FIELD SERVICE CAMPAIGN – 18121

18 December 2018

Front Axle Left-Side Spring Spacer

International® MV™ Series and DuraStar®

Figure 1. Spacer

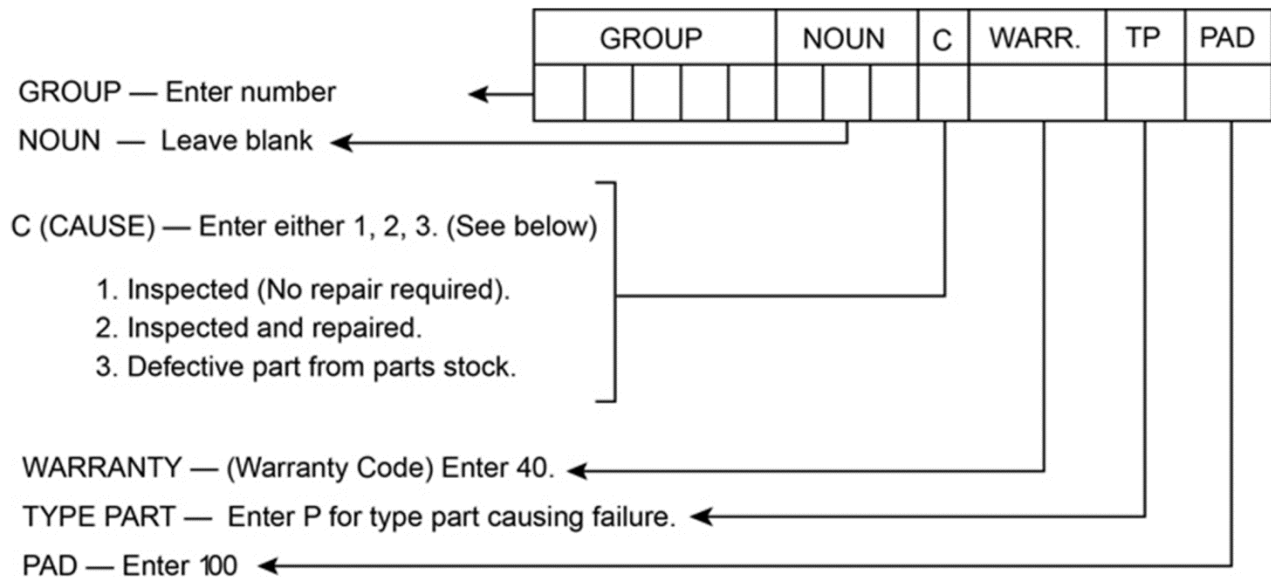
Certain MV™ Series and DuraStar® models may have been built with an incorrect spacer for the left-side front axle spring resulting in a lean condition.

NOTE: Ensure the lower tabs fit into the hole in the axle and the center pin tab of the spring fits into the spacer.

9. Insert spacer (Figure 1) on left-side with tab pointing down.
10. Raise floor jack to remove any space between spacer, axle and spring.
11. Install new U-bolts.
12. Using a torque wrench, in a diagonal pattern, tighten U-bolts in 50 lb-ft (68 N•m) increments to a final value of 260 – 300 lb-ft (192 – 222 N•m).
13. Lift vehicle and remove jack stands.
14. Lower floor jack and remove from under vehicle.
15. Remove wheel chocks.
